Appendix D

HAZOP Worksheet and Recommendation List

JGC Corporation LNG Receiving Facilities / FEED

JGC Corporation LNG Terminal HAZOP

Node1

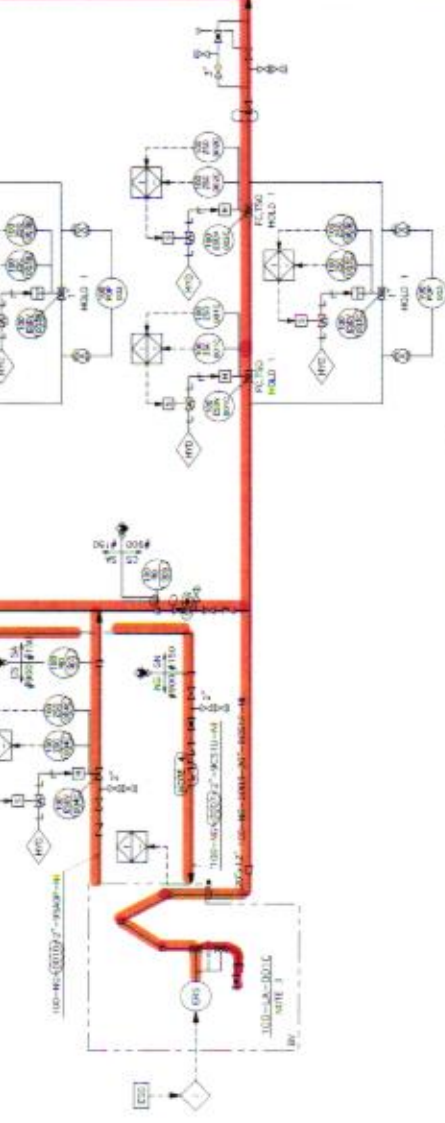
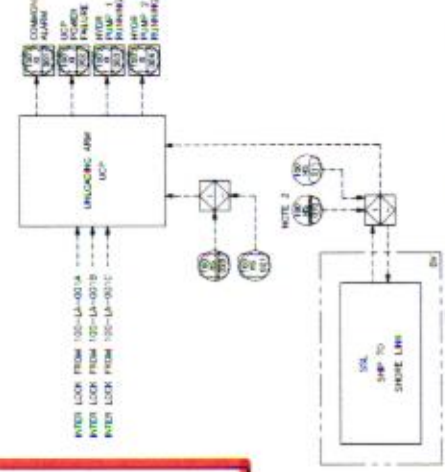
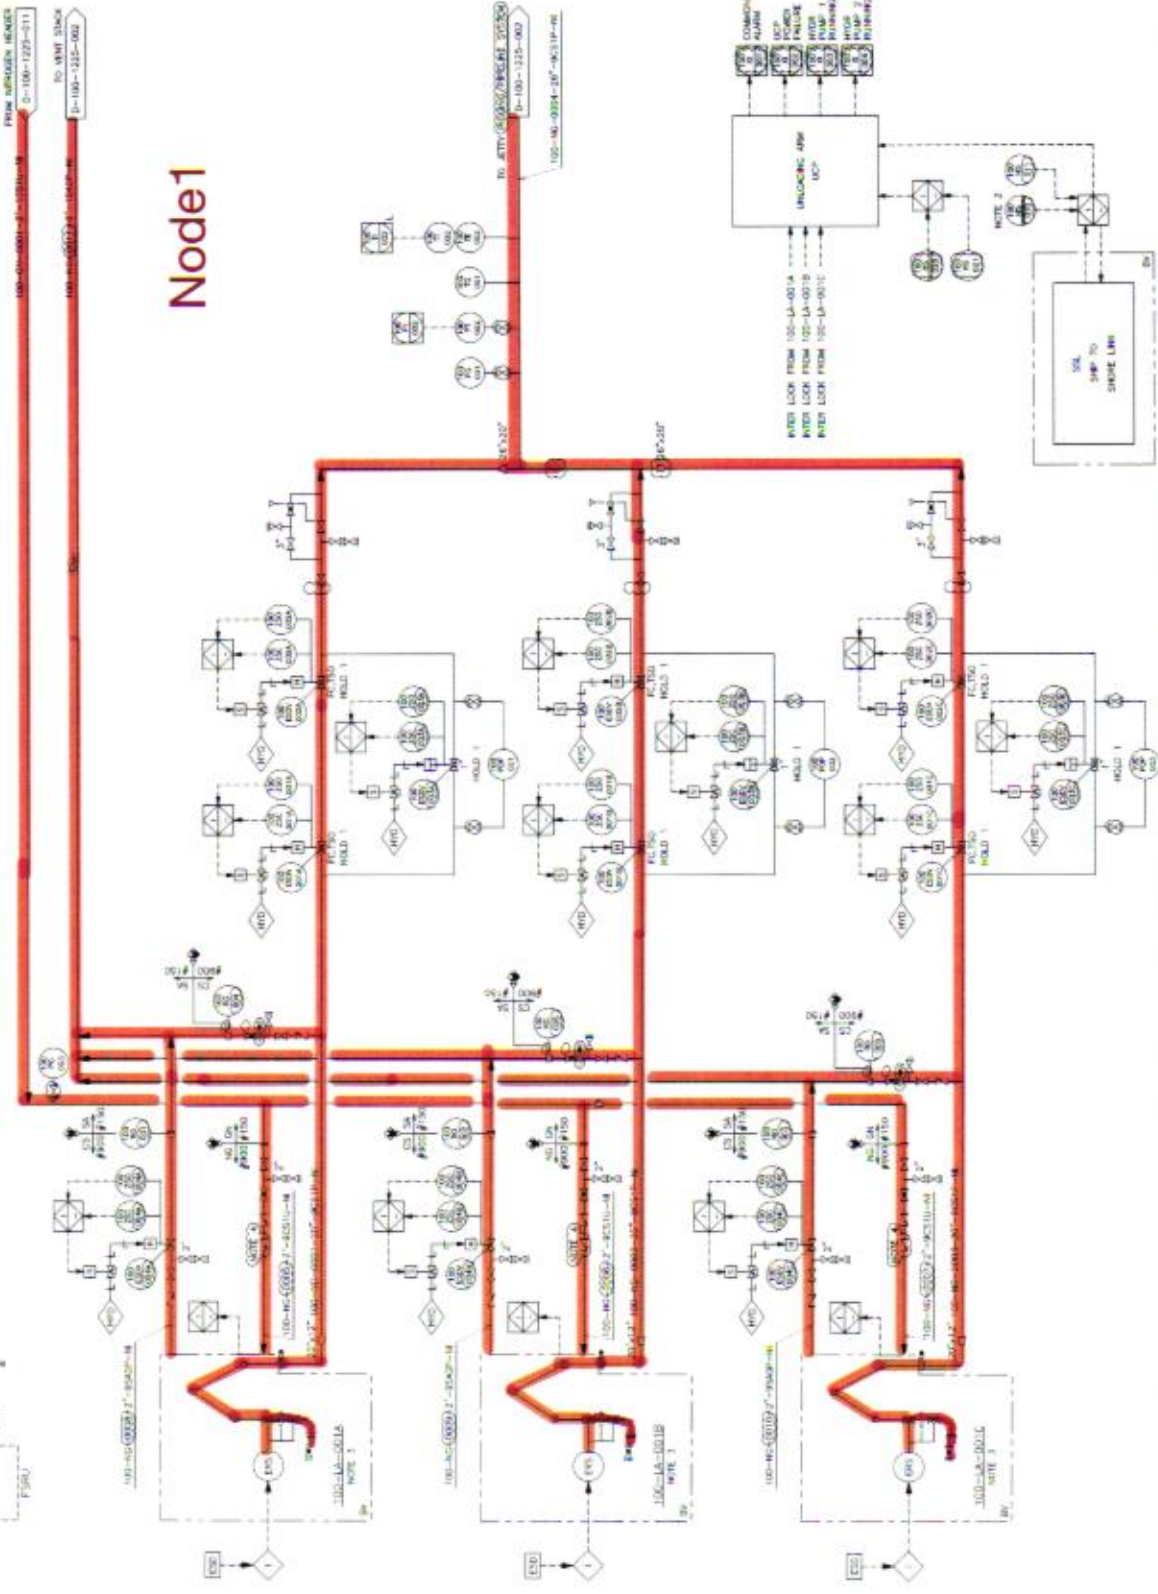
Deviation	Cause	Consequence	Effective Safeguards	Recommendations	Responsibility
1. No/ Less Flow	1. Closure of ERS valves	1. Less sendout to consumers		2. As per SIGTTO requirement, specify with vendor to provide limit switch for ERS valves with position indication to initiate ESD1 (FEED stage)	JGC

3. Pressure built up on FSRU side	1. Protection provided on FSRU side		
	2. Closure of 100ESDV001A2A	1. Less sendout to consumers	1. 100ZSC001/2A position indication	3. Review the protection provided on the FSRU side after FSRU vendor selection and whether alarm is provided from FSRU side in case of pressure built up. (EPC stage)	EPC Contractor

3. Pressure built up on FSRU side	1. Protection provided on FSRU side		
	3. Closure of 100ESDV004	1. No sendout to consumers	1. 100ZSO004 position indication	4. Provide alarm in case of 100ESDV004 is not open (FEED stage)	JGC

2. 25 inch bypass line across 100ESDV004	5. Review ESD requirement (fire and gas emergency) for 25 inch bypass line across 100ESDV004 as per ESD emergency philosophy (FEED stage)	JGC

3. Reverse/ Misdirected Flow	1. 100ESDV004MB on 2 inch piping 100-NG-0008/9-2'-9SAOP-NI on the arms malfunction and left open	1. Gas sendout to atmosphere through vent stack	1. Limit switch 100ZSC004MB provided on 2 inch piping 100-NG-0008/9-2'-9SAOP-NI 2. 100R0001/2 on 2 inch piping 100-NG-0008/9-2'-9SAOP-NI

4. High Pressure	1. No additional cause				
5. Low Pressure	1. No additional cause				
6. High Temperature	1. No additional cause				
7. Low Temperature	1. Low temperature from FSRU (minimal operating temp. can be -2 degC)	1. Could exceed the minimal allowable temperature at the tie in point which is 5 degC	1. 100TE002 alarm provided on piping 100-NG-0004-26'-SCS1P-NI to pigging system	7. Confirm FSRU will shutdown in case temperature drop below 5 degC to align design temperature between FSRU and tie in point (FEED stage) 6. Confirm tie in condition with pipeline company including minimal / maximum allowable / design temperature to align design temperature between FSRU and tie in point (FEED stage) 21. Consider providing low temperature alarm on 300T001 on the downstream of metering station (FEED stage)	Owner / FSRU vendor JGC

11. Utility failure	1. Nitrogen supply failure	1. Delay in maintenance activities 2. Loss of purging to the jetty vent stack 100-S-001 leading to potential vent fire 3. Inability to purge the arm for reconnection		9. Confirm low pressure alarm is provided on the low nitrogen supply (FEED stage) 9. Confirm low pressure alarm is provided on the low nitrogen supply (FEED stage) 9. Confirm low pressure alarm is	JGC JGC JGC

Deviation	Cause	Consequence	Effective Safeguards	Recommendations	Responsibility
12. Start-up/ Shutdown/ Maintenance	2. Power failure from FSRU	1. Loss of power to Hydraulic Power Units and instruments 2. Loss of power lead to ESD1	1. Loss of power initiate ESD1	provided on the low nitrogen supply (FEED stage) 10. Confirm if Emergency Diesel Generator provide backup power to Hydraulic Power Units (HPU) and Uninterruptible Power Supply (UPS) (FEED stage) 11. Review the requirement to shut down the jetty on loss of power from FSRU (Currently loss of power FSRU shutdown the entire jetty) (FEED stage)	JGC JGC

1. Initial startup may lead to low temperature due to JT effect 2. Trapped pressure in between valves 100ESDV001A and 100ESDV002A on pipelines to pigging system 3. Misoperation of valve attached jetty vent stack 100-S-001	1. Potential loss of containment and embrittlement 1. Potential safety impact during maintenance		8. Startup philosophy to be developed to avoid low temperature and embrittlement during startup (FEED stage) 12. Make sure 100ESDV001/2A are provided with bleed to prevent high pressure gas trapped between valves (FEED stage) 23. Provide goose neck design on the jetty vent stack 100-S-001 (FEED stage)	JGC JGC

Node 3 2

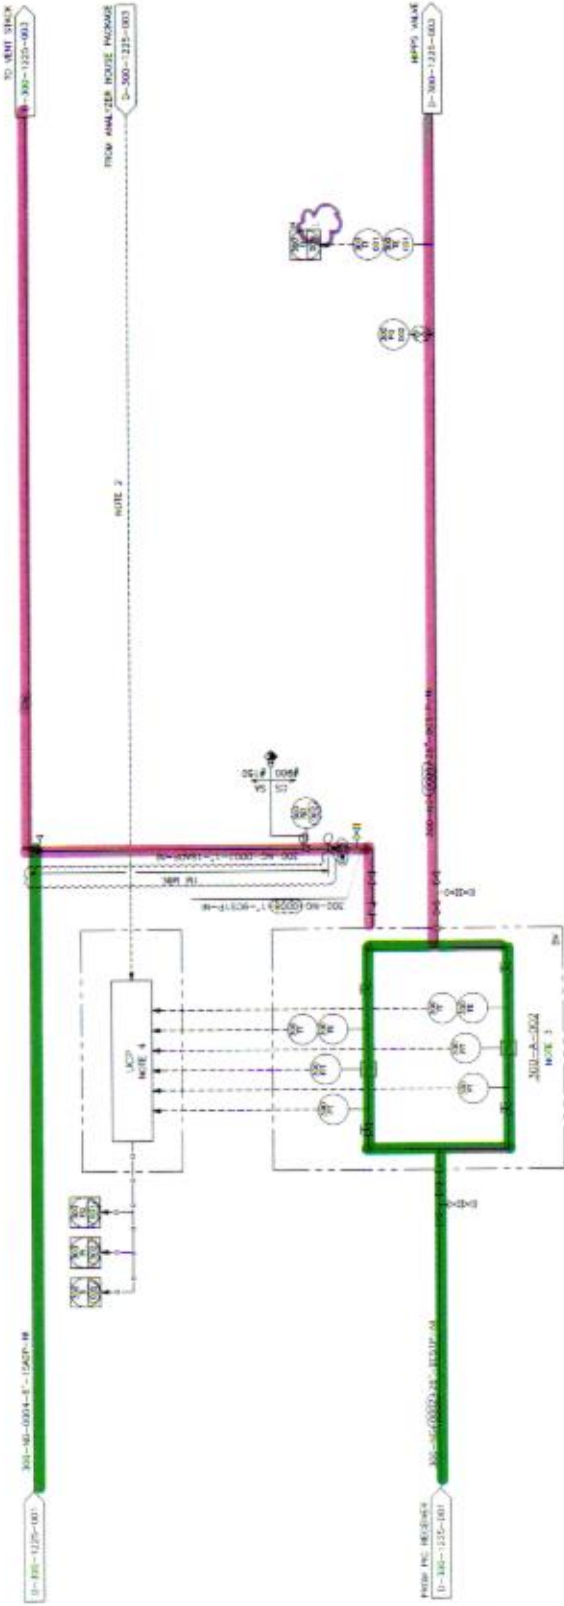
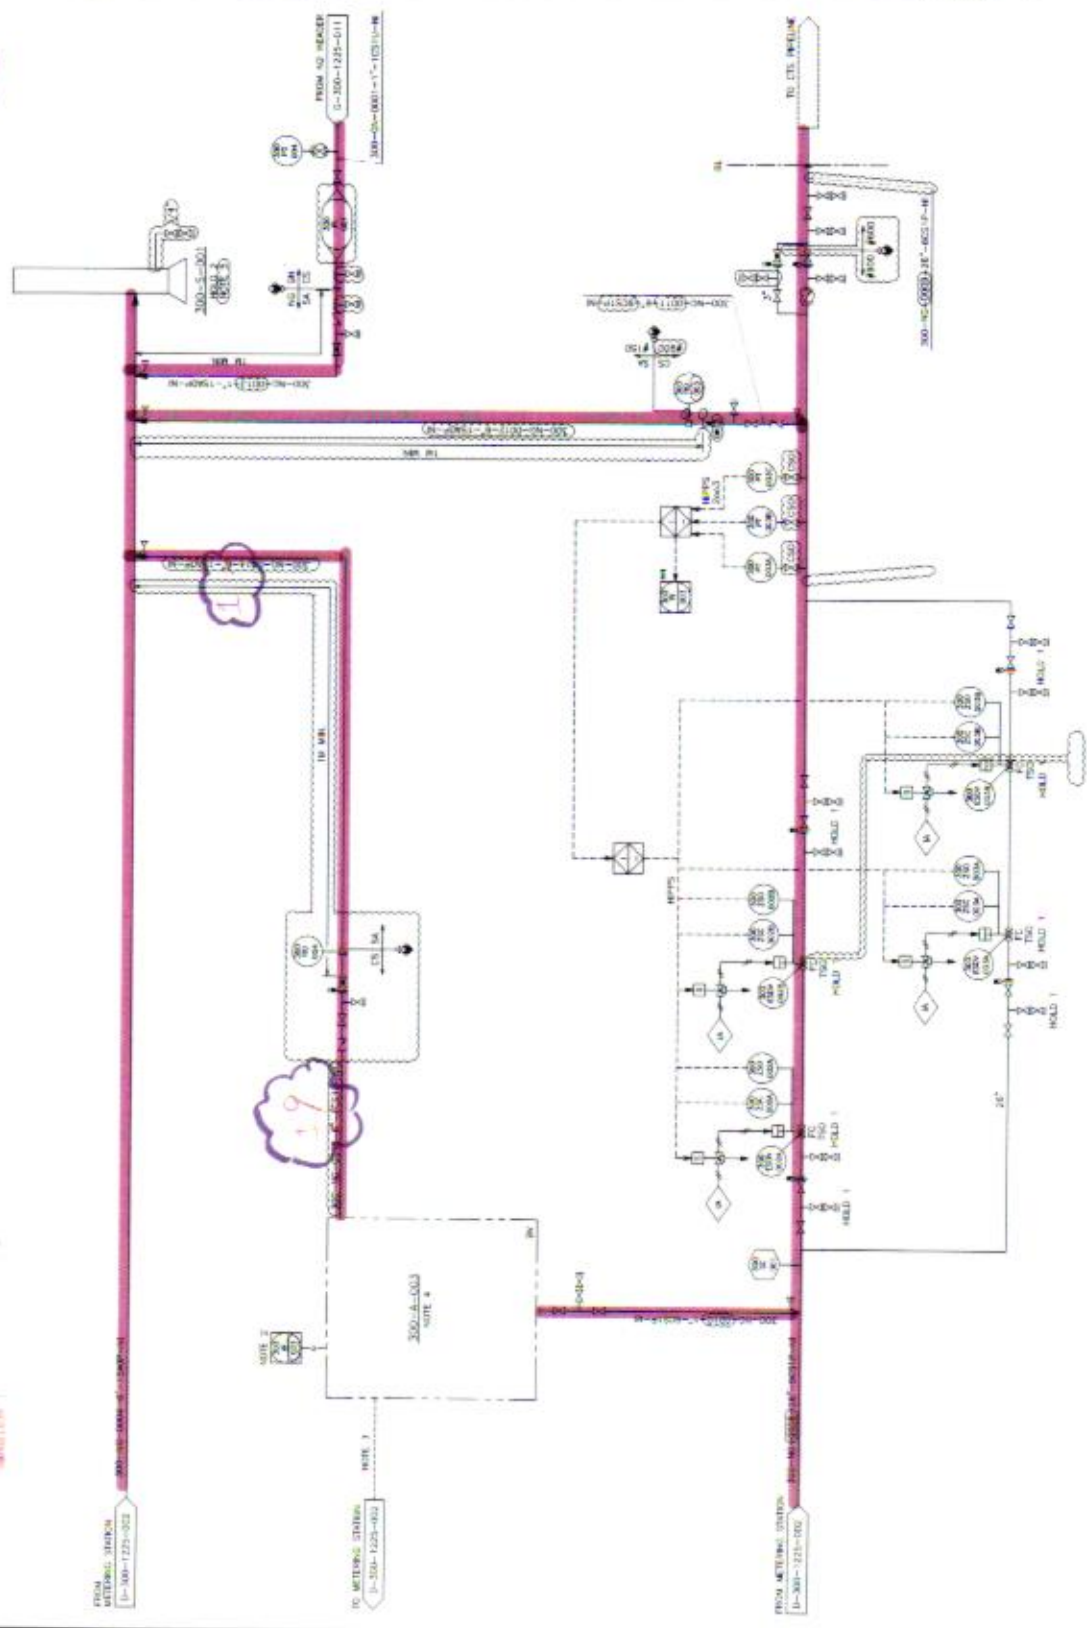
Deviation	Cause	Consequence	Effective Safeguards	Recommendations	Responsibility
1. No/ Less Flow	1. 300ESDV002A/B valves downstream of metering station closed	1. No shutdown to consumers	1. 300ZSO002A/B position indication. 2. 26 inch bypass line via 300ESDV003A/B 3. HIPPS is provided with 2003 voting system on the downstream side of metering station

2. More Flow	1. No additional cause	2. Less flow and pressure built up on upstream side of 300ESDV002A/B	1. Protection provided on FSRU side		
3. Reverse/ Misdirected Flow	1. Reverse flow from CTS pipeline 2. Misoperation of 3" check valve on bypass line to 26" piping 300-NG-0009-25"-6CS1P-NI	1. Operability issue 1. Reverse flow from CTS pipeline leading to operability issue	1. Check valve downstream of HIPPS	15. Develop a procedure for operating the check valve bypass line at CTS pipeline in point to prevent reverse flow from CTS pipeline (FEED stage)	JGC

4. High Pressure	1. Block condition on the CTS user side 2. Closure of valve downstream of analyzer house package 300-A-003	1. Overpressure condition 1. Potential overpressure on the analyzer side	1. HIPPS 300PI003 with HH alarm is provided on the downstream of metering station	17. Consider providing high pressure alarm upstream of CTS pipeline (FEED stage) 18. Specify overpressure protection in datasheet for analyzer house package 300-A-003 (FEED stage)	JGC

5. Low Pressure	1. No additional cause			19. Review piping spec location on the analyzer vent 300-NG-0015-1", 1CS1P-NI to prevent overpressure(FEED stage)	JGC

Deviation	Cause	Consequence	Effective Safeguards	Recommendations (FEED stage)	Responsibility
		2. Loss of purging to the ORF vent stack 300-S-001 leading to potential vent fire		9. Confirm low pressure alarm is provided on the low nitrogen supply (FEED stage) 22. Consider separating the vent for analyzer 300-A-003 to avoid continuous purging N2 and to prevent gas accumulation in the ORF vent stack 300-S-001 (FEED stage)	JGC JGC

12. Start-up/ Shutdown/ Maintenance	1. Misoperation of valve attached ORF vent stack 300-S-001	1. Potential flammable mixture in the vent stack 300-S-001		24. Provide goose neck design on the ORF vent stack 300-S-001 (FEED stage)	JGC

Node 4

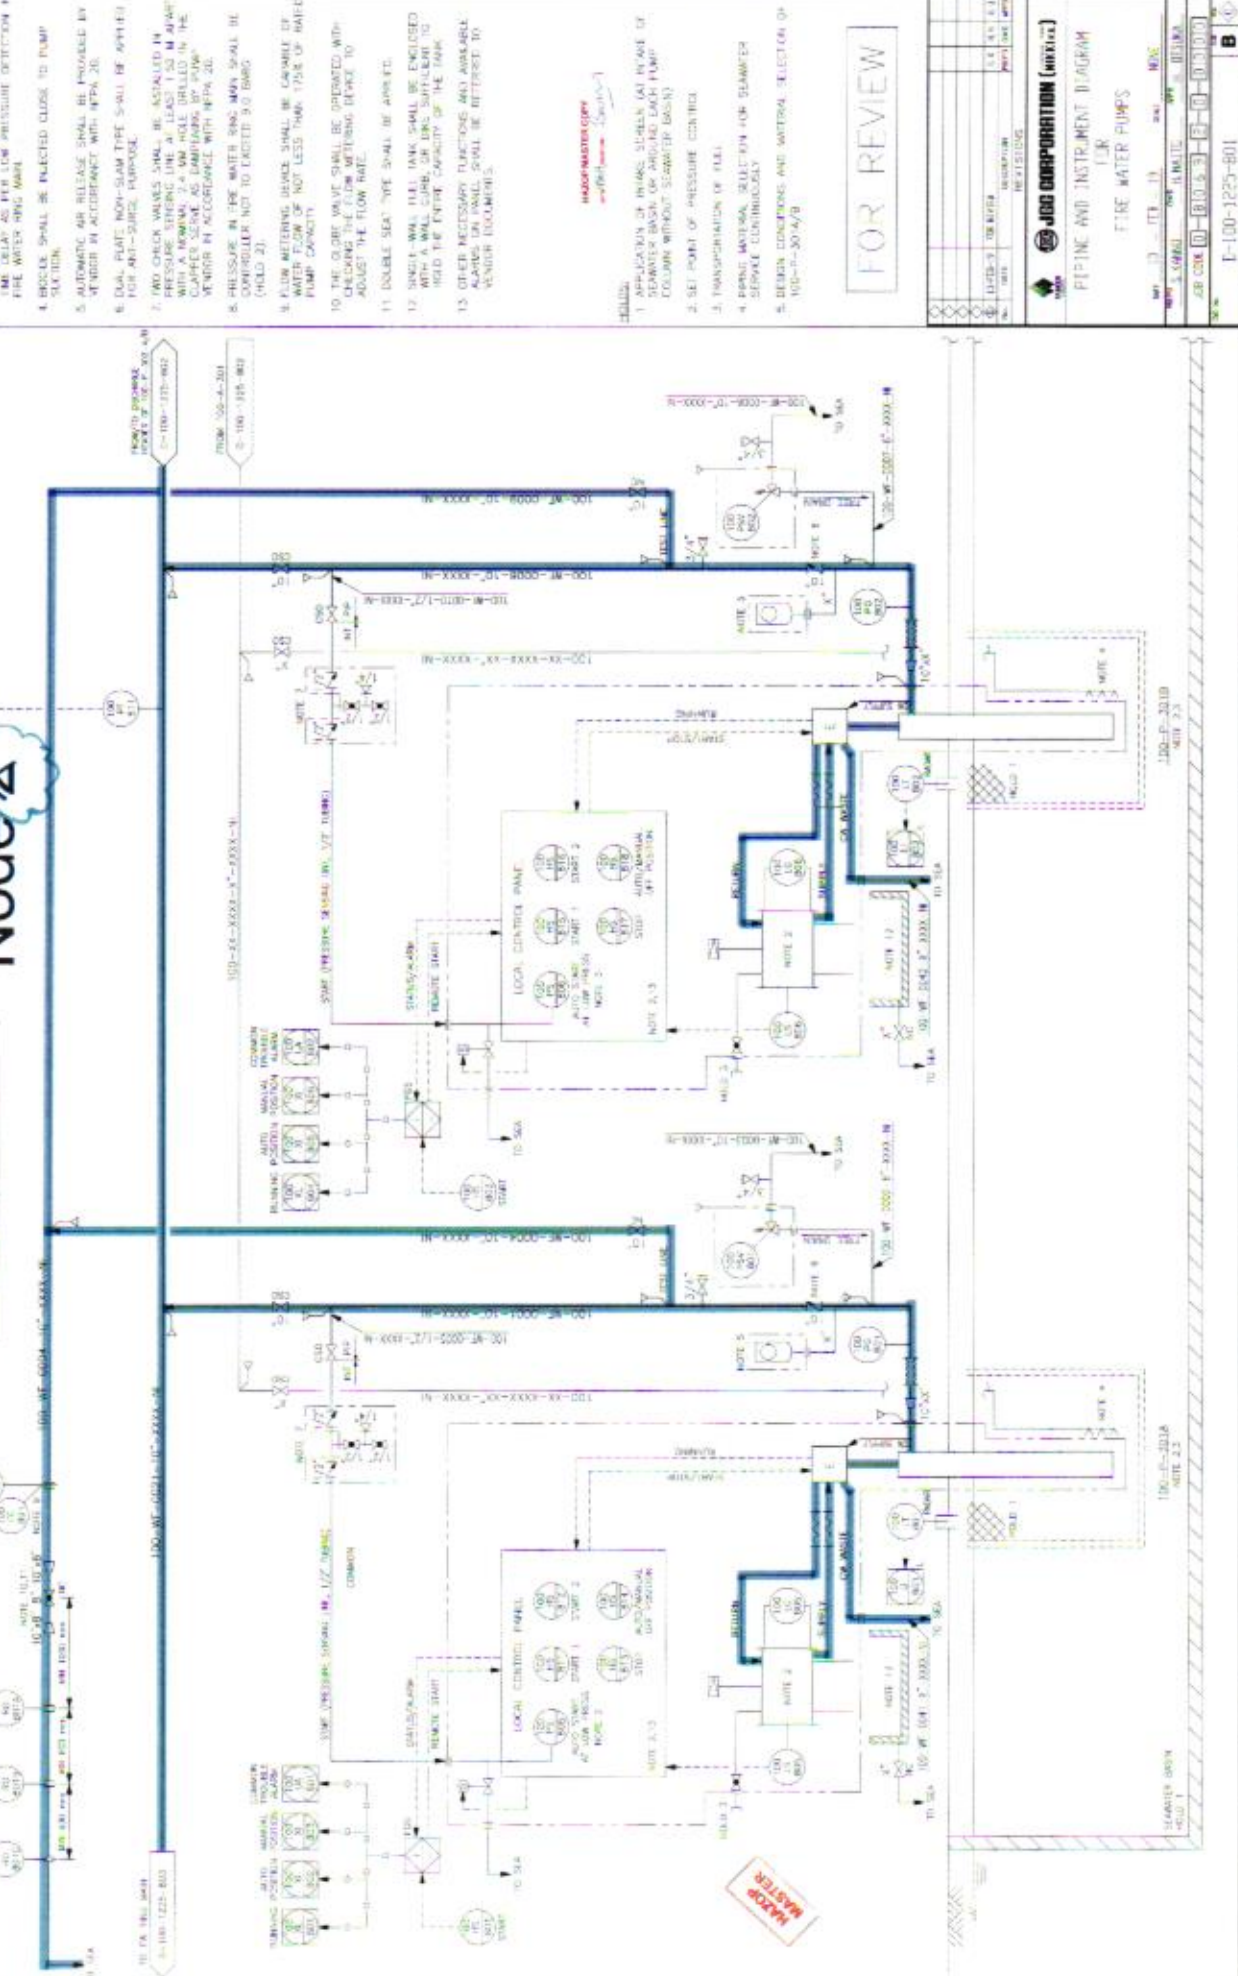
Deviation	Cause	Consequence	Effective Safeguards	Recommendations	Responsibility
1. No/ Less Flow (normal operation)	1. Jockey pump 100-P-302A/B trip	1. Pressure drop and fire water pumps 100-P-301A/B start when not required	1. Pump running status 2. Standby jockey pump (manual start)	26. Provide low pressure alarm to indicate pressure drop before main water pumps 100-P-301A/B start (FEED stage)	JGC

2. Fouling on the piping due to marine growth	1. Pressure drop and fire water pumps 100-P-301A/B start when not required	1. Biocide injection at the intakes	26. Provide low pressure alarm to indicate pressure drop before main water pumps 100-P-301A/B start (FEED stage)	JGC

3. Hydraulic pressure loss in the piping system (eg fire water pumps check valves / PSV / valve 100PV811 passing)	1. Pressure drop and fire water pumps 100-P-301A/B start when not required	1. Biocide injection at the intakes	26. Provide low pressure alarm to indicate pressure drop before main water pumps 100-P-301A/B start (FEED stage)	JGC

11. Composition/ Concentration Change & Contamination				28. Review whether biocide is acceptable to be injected continuously for the main water pumps (from environmental perspective) (FEED stage)	EPC Contractor

2. Seawater quality change	1. Potential fouling of fire water pumps 100-P-301A/B diesel engine leading to damage		32. Specify fire water pumps to be designed with sufficient allowance for fouling and corrosion (FEED stage)	JGC

12. Utility failure	1. Loss of nitrogen supply	1. Inability to operate the deluge valve on piping 100-WF-0025-6'-XXXX-NI		36. Provide pressure indication to indicate loss of nitrogen supply on volume bottles and indicate on PIDs with note (FEED stage)	JGC
